From: Kunkel, Tara S [<mailto:tara.kunkel@CBIFederalServices.com>]
Sent: Monday, January 30, 2017 2:26 PM
To: Agnew, Diane, NMENV <Diane.Agnew@state.nm.us>
Cc: adria.bodour.1@us.af.mil; Matt Ellender (matthew.b.ellender@usace.army.mil)
(matthew.b.ellender@usace.army.mil) <matthew.b.ellender@usace.army.mil>; Simpler, Trent SPA
(Trent.Simpler@usace.army.mil) <Trent.Simpler@usace.army.mil>; Romalia, Kathleen
<Kathleen.Romalia@CBIFederalServices.com>; Burke, Bruce <bruce.burke@CBIFederalServices.com>;
McBride, Randy <Randy.McBride@CBIFederalServices.com>; LaChance, Caitlin Q
<caitlin.lachance@CBIFederalServices.com>; CLARK, SCOTT C GS-12 USAF AFMC 377 MSG/CEIR
(scott.clark@us.af.mil) <scott.clark@us.af.mil>; suzanne.devergie@us.af.mil
Subject: Requesting NMED approval, KAFB-106MW2 relocate due to original borehole abandonment
Importance: High

Subject: FW: Evaluation of borehole for KAFB-106MW2

Subject: [EXTERNAL] Evaluation of borehole for KAFB-106MW2

FIGURE 6

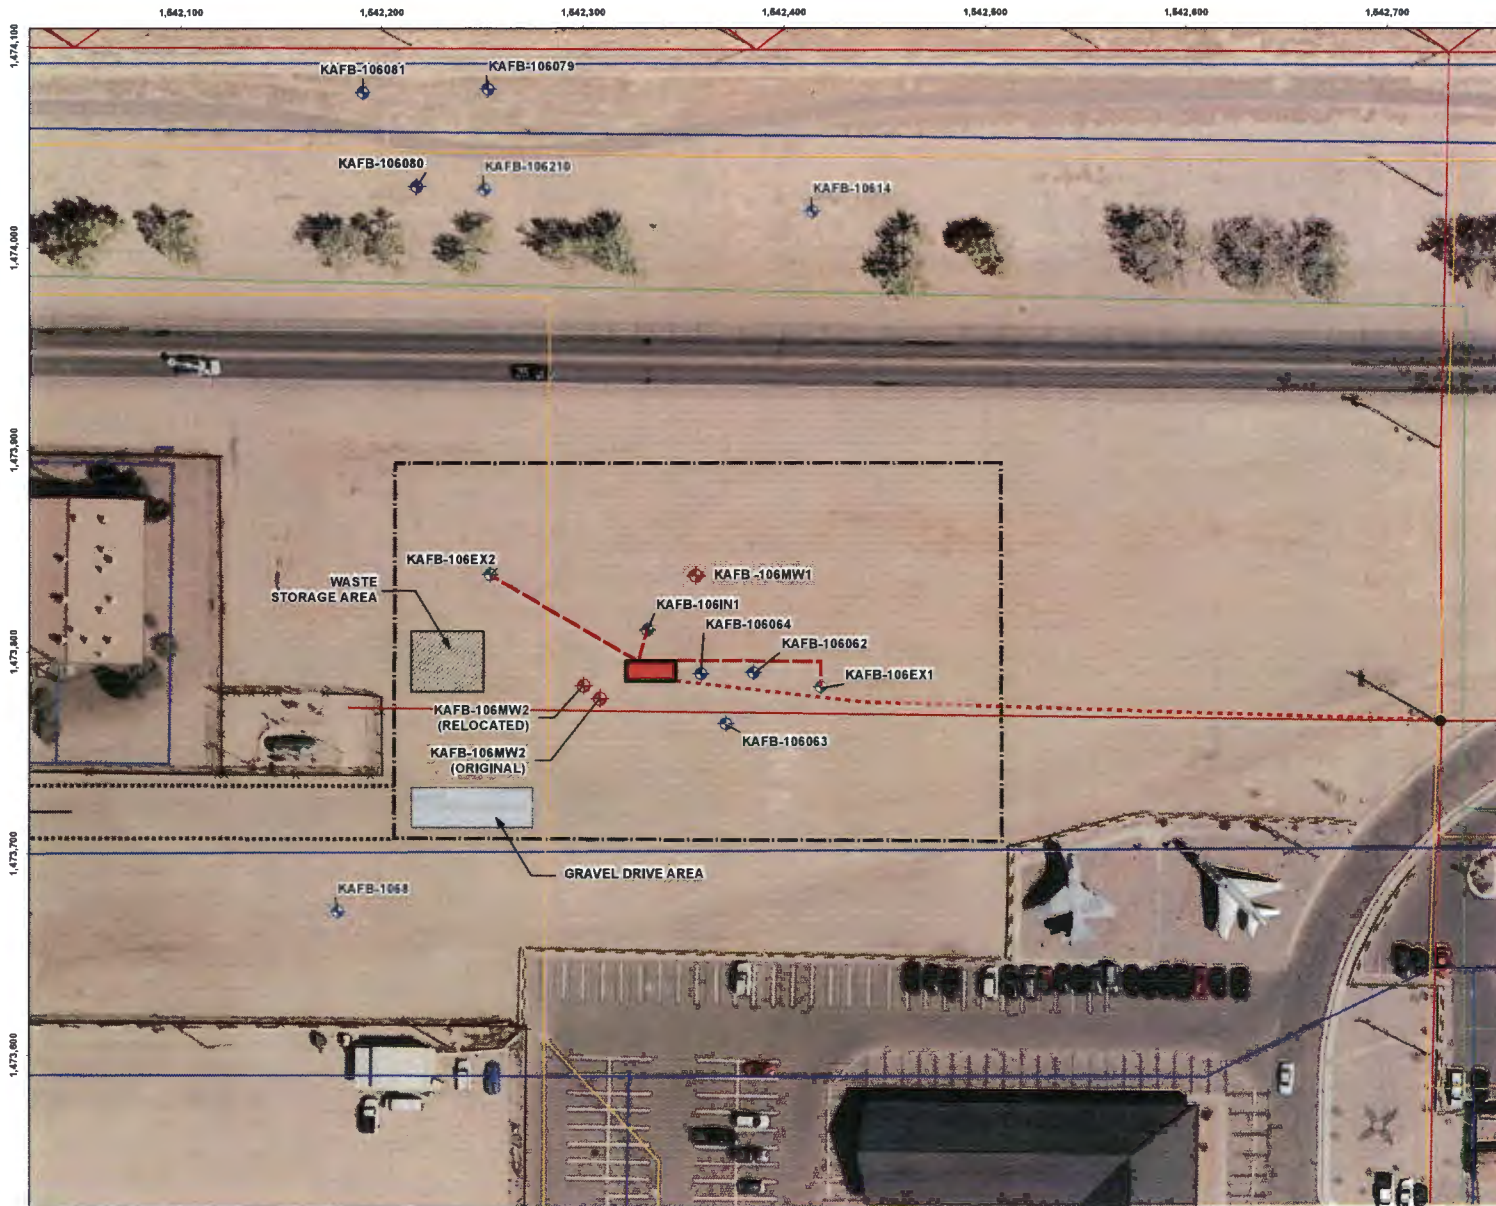
Please find attached a map that shows the proposed relocation of KAFB-106MW2 due to having to abandon the original borehole because of deviation. The borehole will be located 10 feet north-west of the original location. All the deviation observed at the original borehole is to the east south-east, so this location should not interfere with the original location.
